Work Order ID: 107058

Parent Item Name: Mounting Lug

DRAWING NO. D2731	TITLE MOUNTING LUG	REV. C	DART AEROSPACE USA, INC ENGINEERING ORDER		D.E.O. NO. D2731-C-1	SHEET NO. SHEET 1 OF 1	SCALE NTS
DRAWN <i>q2</i>	CHECKED <i>Sc</i>	MFG. APPR. <i>NA</i>	APPROVED <i>MD</i>		DE APPR. <i>MD</i>		
DATE 11.05.02	DATE 11.05.09	DATE 11.05.09	DATE 11.05.09		DATE 11.05.09

D2731-1RG MOUNTING LUG (SHOWN)
D2731-3RG/-5RG/-7RG MOUNTING LUGS (SIMILAR)

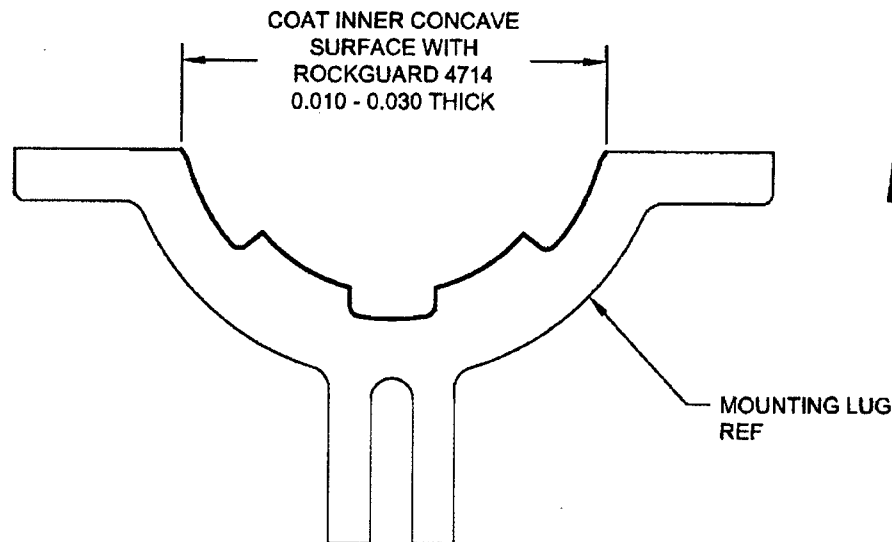
ADD D2731-xRG OPTION

D2731-xRG MOUNTING LUGS ARE INDENTICAL TO D2731-x MOUNTING LUGS, HOWEVER AFTER FINISH, COAT INNER CONCAVE SURFACE WITH "PLUS ONE ROCKGUARD 4714" AS SHOWN BELOW.
